A d d e n d u m

Iowa Department of Transportation
Office of Contracts

B.O.	Proposal ID	Proposal Work Type	County	Project Number	Addendum
116	97-0297-048	PCC PAVEMENT - GRADE & REPLACE	WOODBURY	IM-NHS-029-7(048)149--03-97	17MAR116.A01

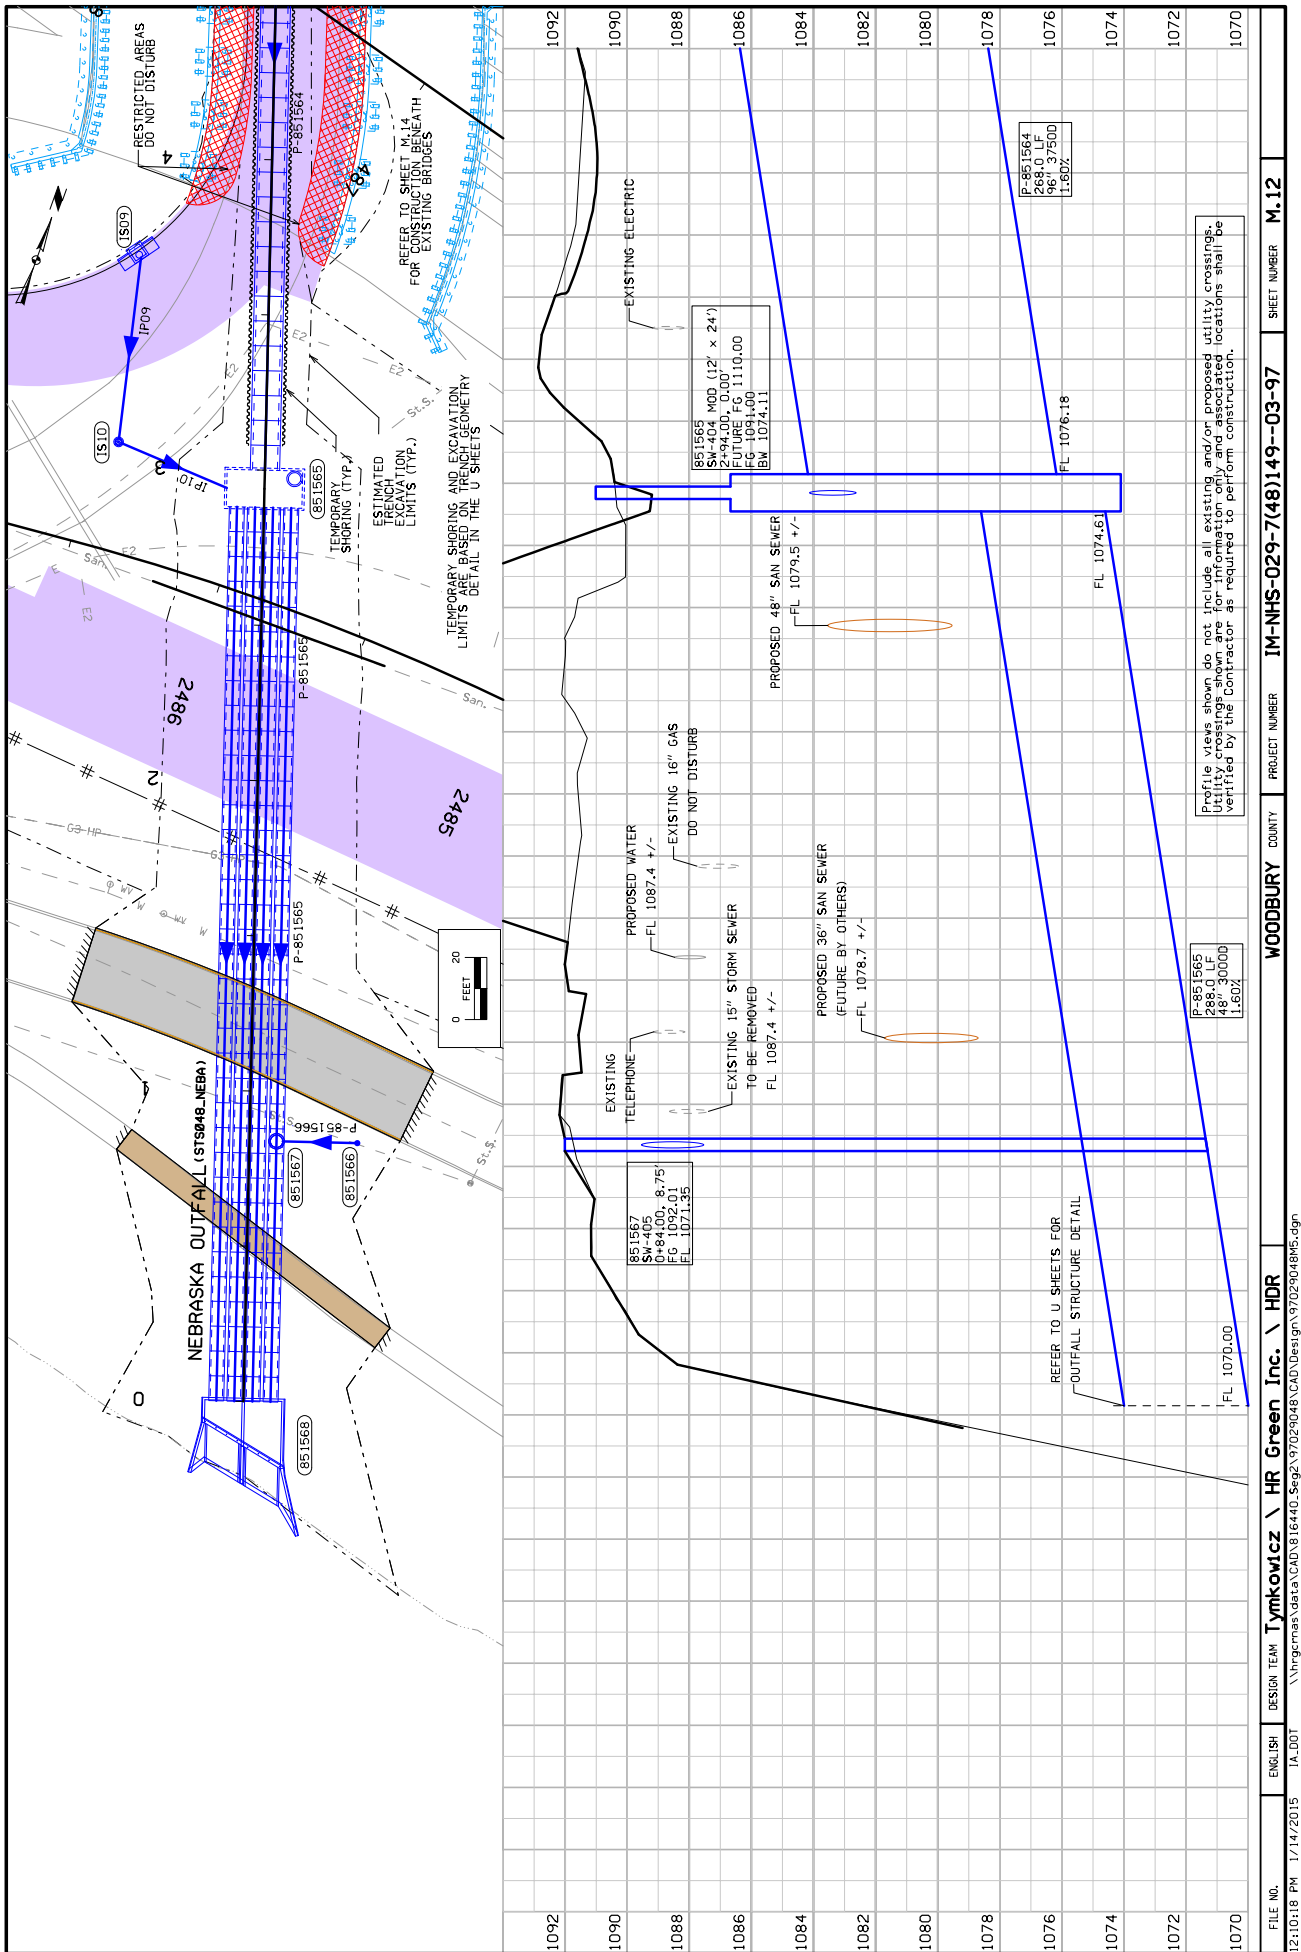
Replace Plan Sheet C.9 with the attached Plan Sheet C.9. Revised Tab 111-25 continuation point.

FILE NO.	DESIGN TEAM	COUNTY	PROJECT NUMBER	SHEET NUMBER
121018 PM 1/14/2015	ENGLISH 1A.DOT	WOODBURY	IM-NHS-029-7(48)149--03-97	M.12

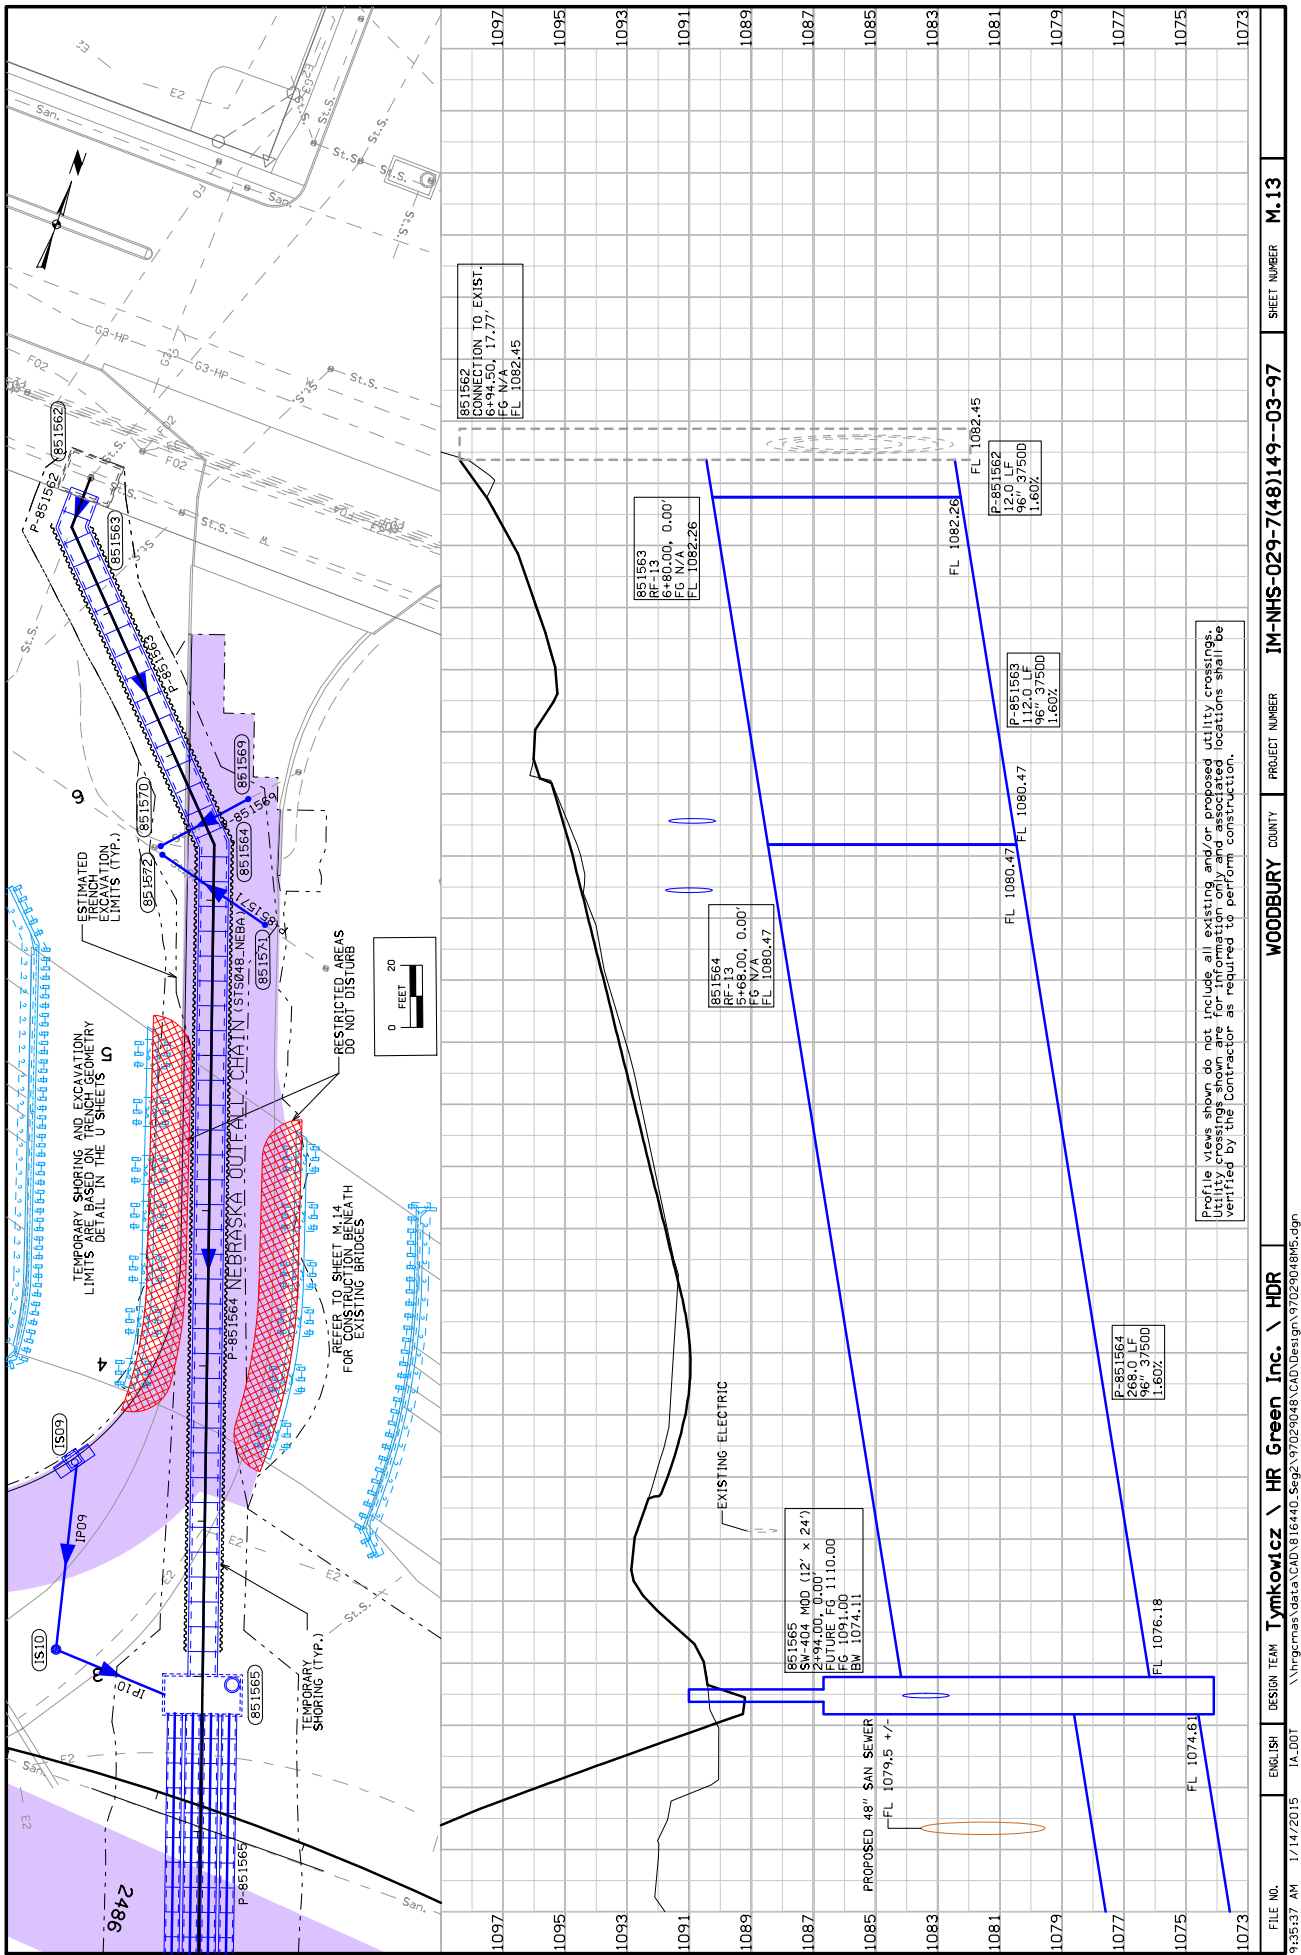
Replace Plan Sheet M.12 with the attached Plan Sheet M.12. Removed utility coordination note.
